RE: Great River Energy’s Alternative Liner Application Under 40 C.F.R. § 257.71(d)(1), for the Upstream Raise 91 Combustion Coal Residual Rule Surface Impoundment at Coal Creek Station.

**Technical Comments on the
Alternate Liner Demonstration Application (ALD) for the CCR Surface Impoundment
called “Upstream Raise 91” at the Coal Creek Power Plant, prepared by Golder and
Associates pursuant to 40 CFR 257.71(d)(1), dated November 30, 2020.**

**by
Dr. Ranajit (Ron) Sahu, Consultant**

¹⁰ ALD, Figure 6 (at p. 54 of pdf).

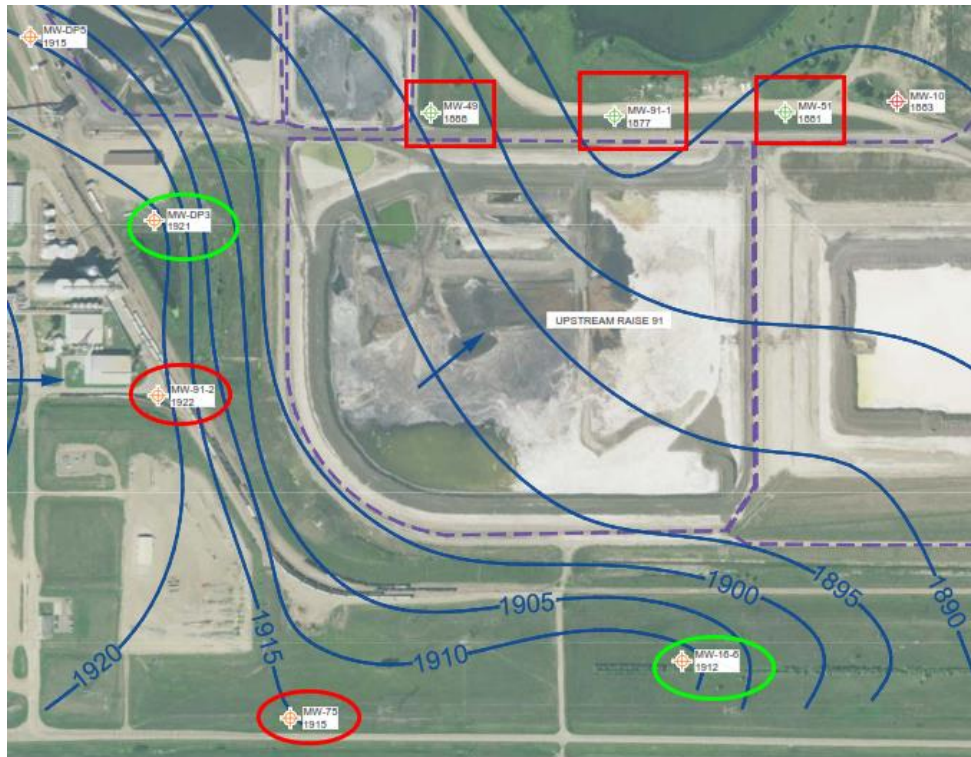
In the figure above, I have shown the two newly added upgradient wells, MW-DP3 and MW-16-6 in green ovals. The other red ovals and boxed wells are identical to the 2019 groundwater monitoring plan locations discussed above. The ALD provides no justification for the addition of these two new wells as upgradient wells other than a conclusionary statement that “[A] review of recent groundwater levels indicated that there are four applicable upgradient wells....”¹¹ The ALD proceeds to conduct an “intra-well” statistical analysis of the spatial differences in groundwater constituent concentrations. Intra-well analyses are highly suspect because they simply compare the groundwater concentrations in each monitoring well to itself over time, and provide no comparison, or information about spatial patterns, between or among monitoring wells. Although the ALD does discuss inter-well analyses generally, it does so for informational purposes only, does not actually conduct any inter-well analysis, and simply asserts that such analyses are not recommended for Coal Creek Station.¹²

¹³ ALD, Figure 26 (at p. 74 of pdf).

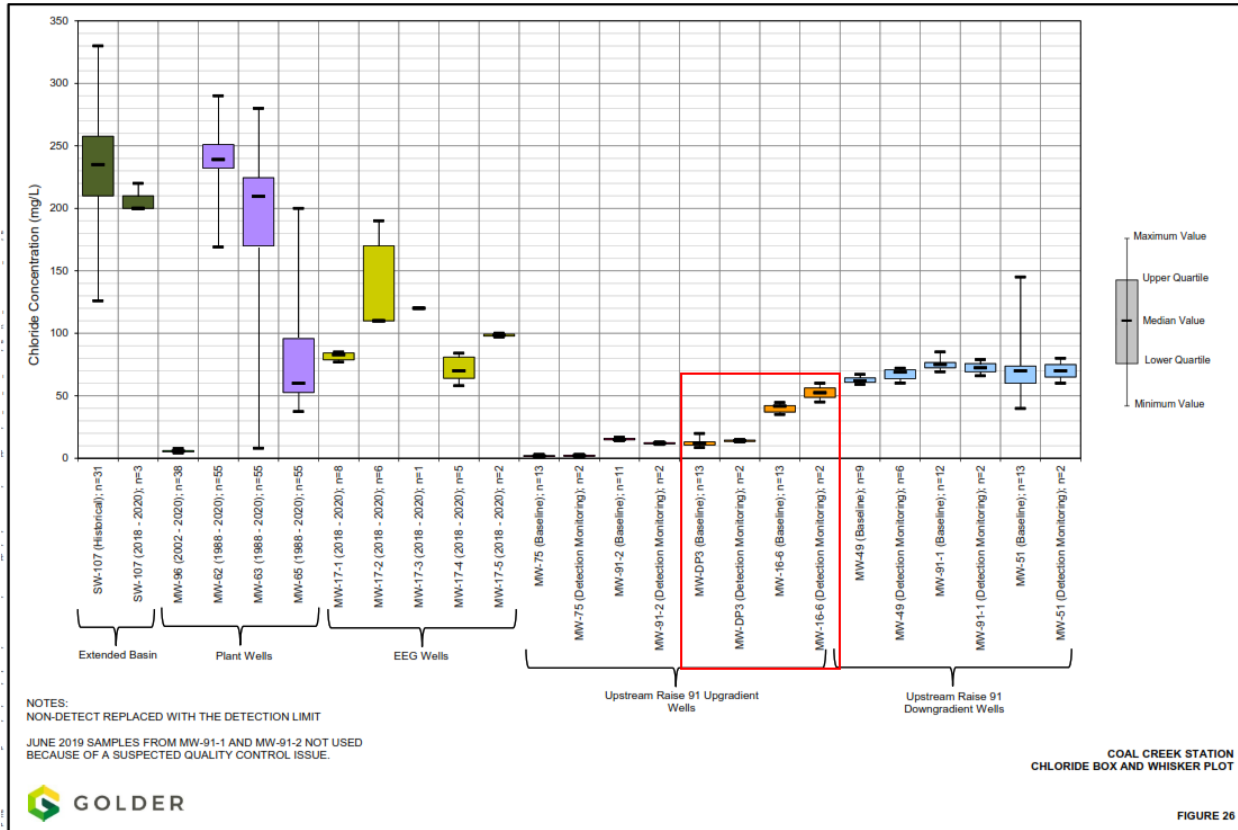
The figure above reflects the four upgradient and downgradient well chloride concentrations for Upstream Raise 91, from the various rounds of sampling. The two original upgradient wells had chloride concentrations of less than 30 mg/L while the three downgradient wells had concentrations between 60-70 mg/L, making them clearly and significantly higher than the upgradient concentrations. However, adding the two new “upgradient” wells, shown in the red box above, skews the comparison because one of the newly added “upgradient” wells (MW-16-6) has chloride concentrations that are between 40-60 mg/L, making it closer to and more comparable with the higher *downgradient* chloride concentrations than a true background well. Thus, adding in MW-16-6 makes it appear that, collectively, the upgradient wells and downgradient wells may have similar concentrations, i.e., the liner may not be leaking. In reality, GRE’s originally certified monitors make clear that the downgradient wells have statistically significant increases in pollutant concentrations, likely as the result of a leaking liner.
